100GBASE-SR4 TDEC & SEC Review Comments r02-36 & r02-37

John Petrilla: Avago Technologies
October 2014

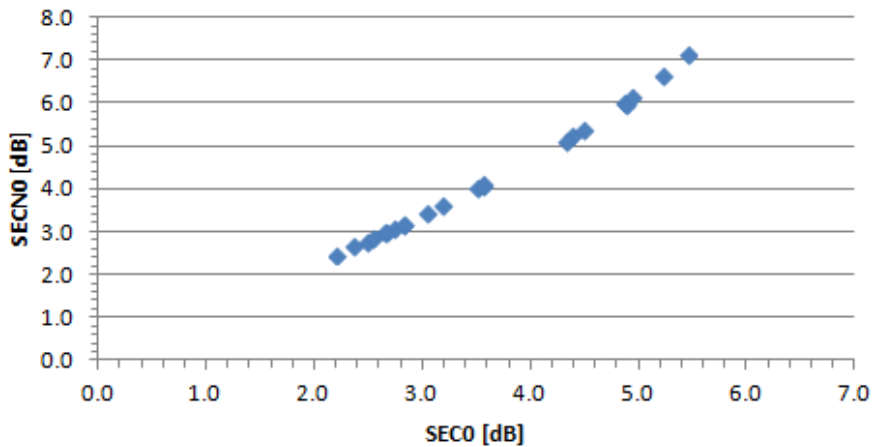
- The effect of M in TDEC and SEC as presently defined appears larger (~ 2x) than the effect of Pmn and Pmpn in the link model. See charts on following pages for results with M = 0 and M active.

- Redefining M such that its effect on TDEC and SEC is reduced by half is recommended.

SECN0 vs SEC0

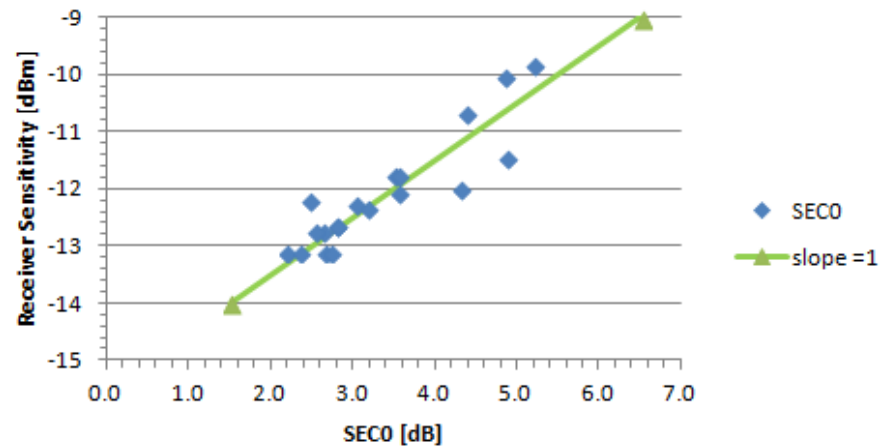
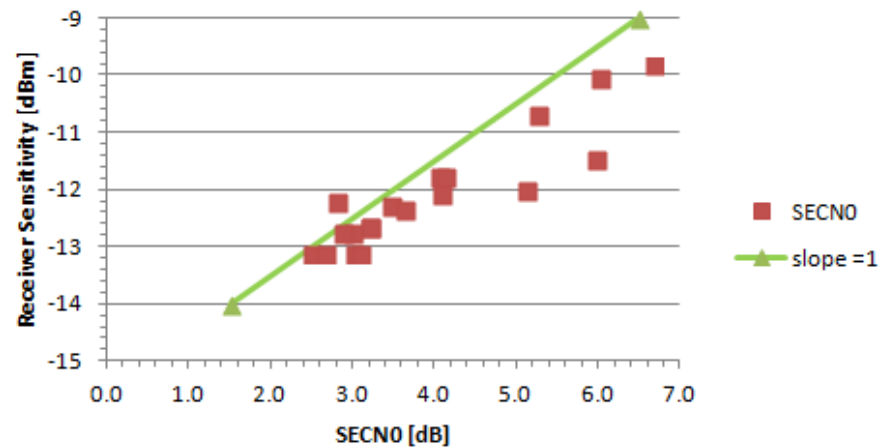
- The top left chart show that the correlation between SEC with M active (SECN0) and M = 0 (SEC0) is very tight and super-linear. The data includes data from 1 m fiber link as well as 150 m fiber links.
- The charts on the left show a more linear correlation between SEC0 (M = 0) and RxS than between SECN0 and RxS.
- It's recommended that the stressed receiver conditions setup continue to use SEC with M = 0 and that stressed receiver sensitivity is adjusted to avoid double inclusion of the stress that M represents.

SECO & SECNO vs TDEC

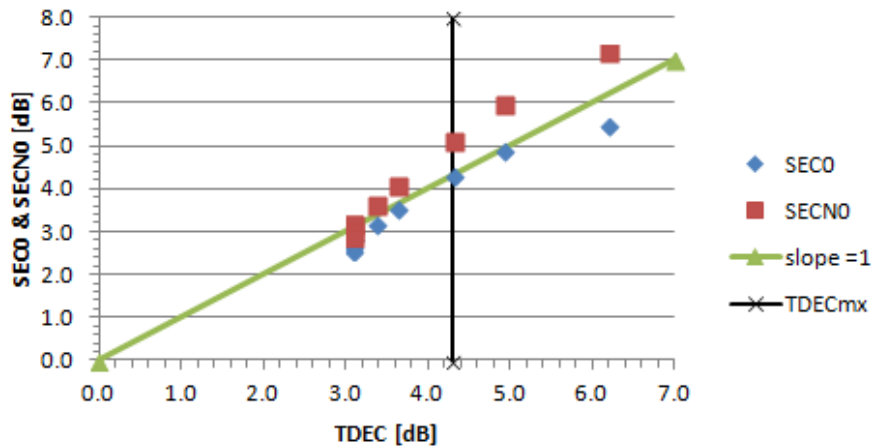
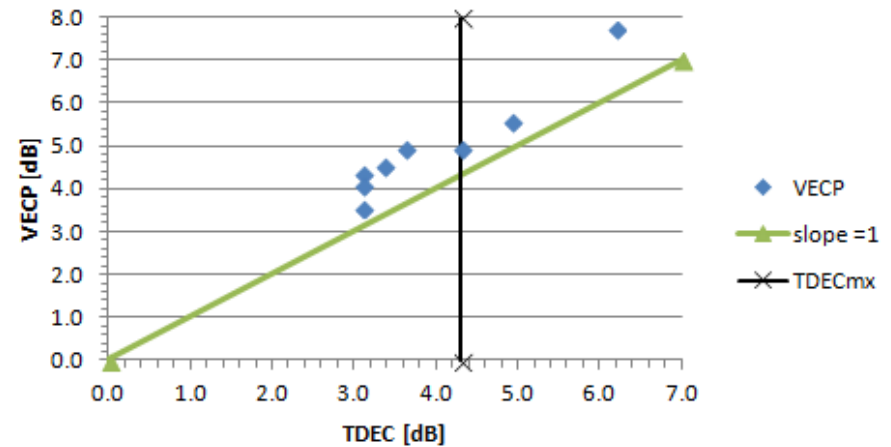
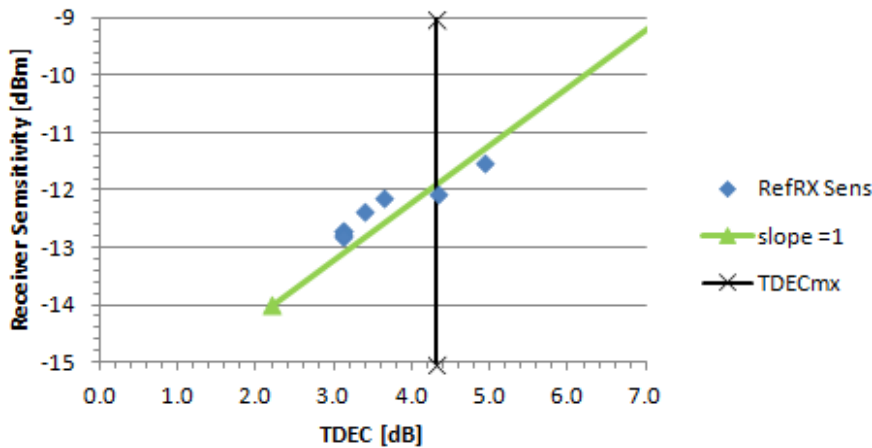
- All the results on the charts on this page are from links with the 150 m OM4 fiber.
- The top left chart shows correlations between TDEC and SECO and SECNO.
- The data indicates that there may be one-to-one correlations between TDEC and SECO, between SECO and RxS and between TDEC and RxS.
- Following the previous recommendation for max TDEC = 4.3 dB a limit line is included on the charts.
- The top right chart shows the correlation between VECP and TDEC results.
